Chilmark Planning;  
Menemsha Corridor Plan for Improvement

**[Analysis + Recommendations]**

Prepared for the:  
Martha's Vineyard Commission and the Town of Chilmark, MA

Additional comments received at conclusion of the final report are addressed below.

Above: Updated North Road parking along Greenebaum property.

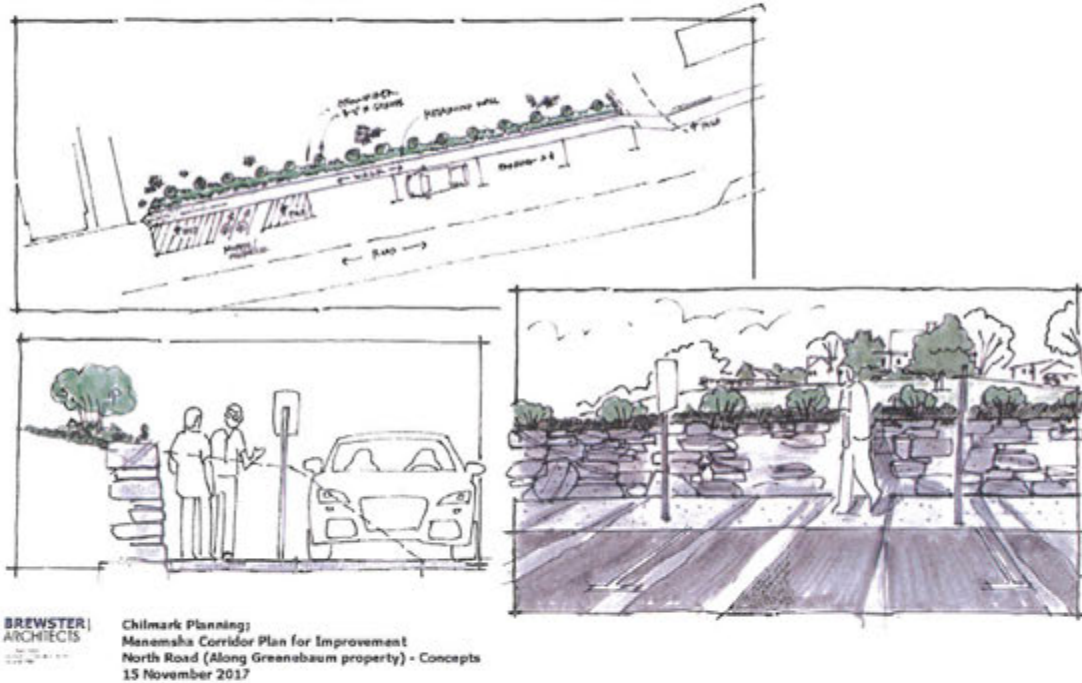
- B.0 Develop drawings showing an overview, an elevation and a section of the North Road/Greenebaum lot area developed for an additional walkway.  
*Response: Additional views of the Greenebaum property have been provided.*

Above: Updated Basin Road (North Road to Dutcher Dock) Concepts drawing showing additional cross-walks at 'The Bite.'

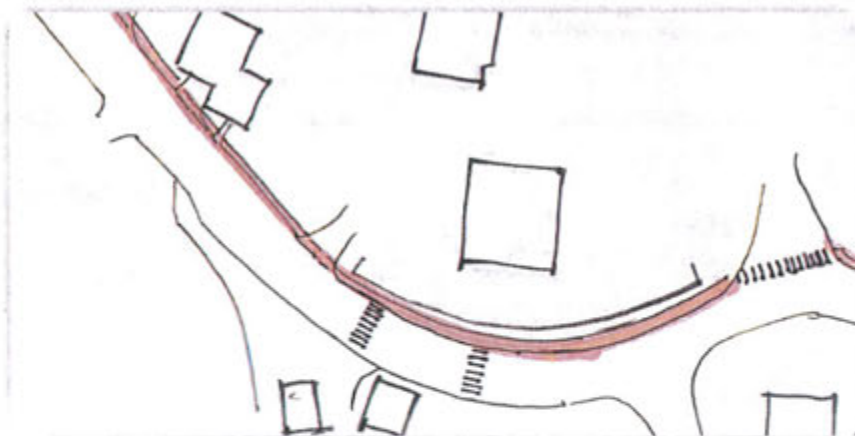
- B1.0 Provide on page 10, more clarification on exactly what is recommended for the Basin Road walkway/path.

- B1.1 Illustrate exactly where the shell/rock path is and where the painted areas and crosswalks are located and can you provide a very clear recommendation for the entire walkway/path in this area so that the person implementing the plan is clear on what is to be done.
- B1.2 Add an additional sketch that fleshes out the Basin Road walkway so that more details could be seen.

*Response: This is shown as much as possible on the 'Overall Key plan - Concepts' as well as the enlarged plan views. Further definition of exactly where there is shell/gravel vs. existing pavement will require a much larger scale engineering drawing/survey to identify and finalize.*

*Response: Further definition of exactly where there is shell/gravel vs. existing pavement will require a much larger scale engineering drawing/survey to identify in the next phase.*

*Generically, wherever there is existing bituminous pavement adjacent to the roadway (i.e., parking for retail and restaurants, etc.), a simple painted path matching the shell/gravel path is proposed over the existing pavement. Discussions indicate that the painted path should be demarcated in solid gray pavement paint with a white painted edge line.*

Above: Looking west toward The Galley.

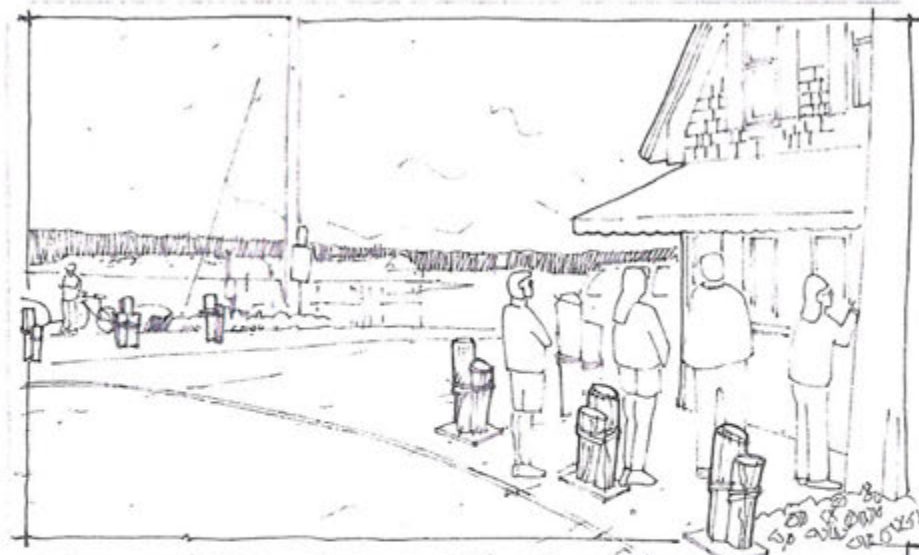
- B2.0 Provide on page 12:
  - a. Provide an additional sketch description and of the waiting area in front of the Galley.

- b. Recommendations #4 & #5 do not appear to be shown on the accompanying sketch.

Above: Alternative Bus Turn-around beyond the Comfort Station, with Bus Shelter on north side.

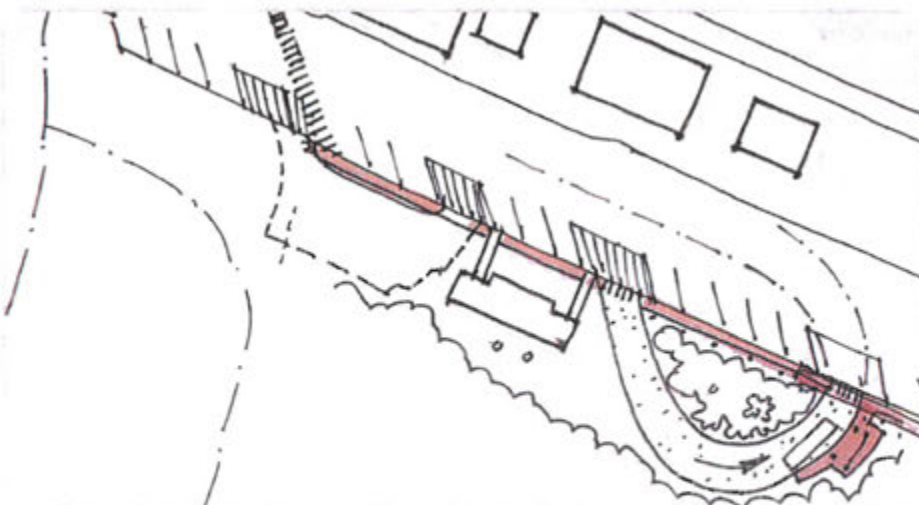
- B3.0 The subcommittee discussed their recent discussion with Kent Healy, engineer, regarding the unlikely feasibility of the VTA buses traveling behind the Comfort Station and the bus turnaround in the rear of the comfort station is not feasible due to the leaching fields being there. Can these be hardened?

- B3.1 Provide sketch at turnaround after the comfort station, on pages 13-15, that the first south side "shell lot" remains and an additional "shell lot" is to be added on the north side of the Comfort Station with a passenger drop-off and embarkation site on that north side.

*Response: It is our experience that leaching fields can be covered over with paving materials, depending on depth of coverage, and base material. I will defer to Mr. Healy on the existing conditions.*

Above: Alternative beach access on north side of headwall and break-water.

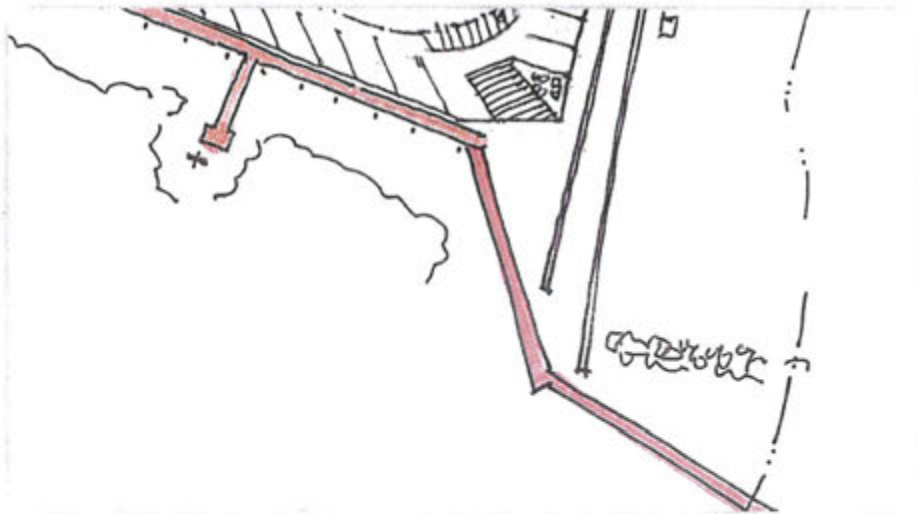
- B4.1 Provide an illustration of how a person using a wheelchair or walker or other type of access vehicles would access the beach from the parking lot.  
*Response: Drawing (p. 8) Dutcher Dock to Menemsha Beach Parking shows the proposed beach access through the new and existing headwall for a fairly direct route to the waterline. Alternatively, the path can be flipped such that the bulkhead can remain as it presently is, and the path configured to the north of the breakwater to the highwater line.*
